PRODUCT CHANGE NOTICE
PCN Form (D4-E000-73)

PCN #06-003

TC Gold Plated Series of RoHS Transformers

Enable use of alternate substrate on TC gold plated series of RoHS transformers

AT224

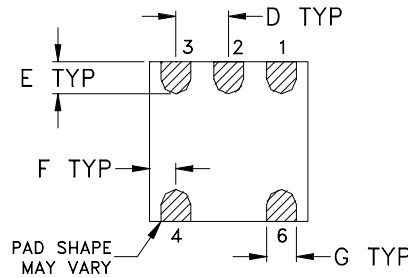
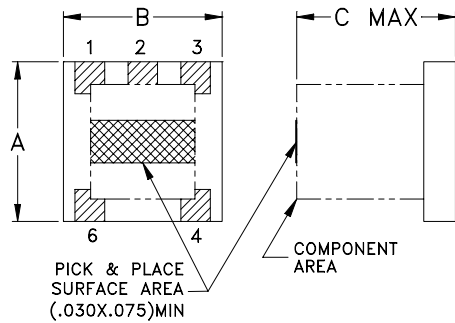
Minor modification of substrate form (see drawings).
No change in internal components, processes, customer footprint, fit, or function.
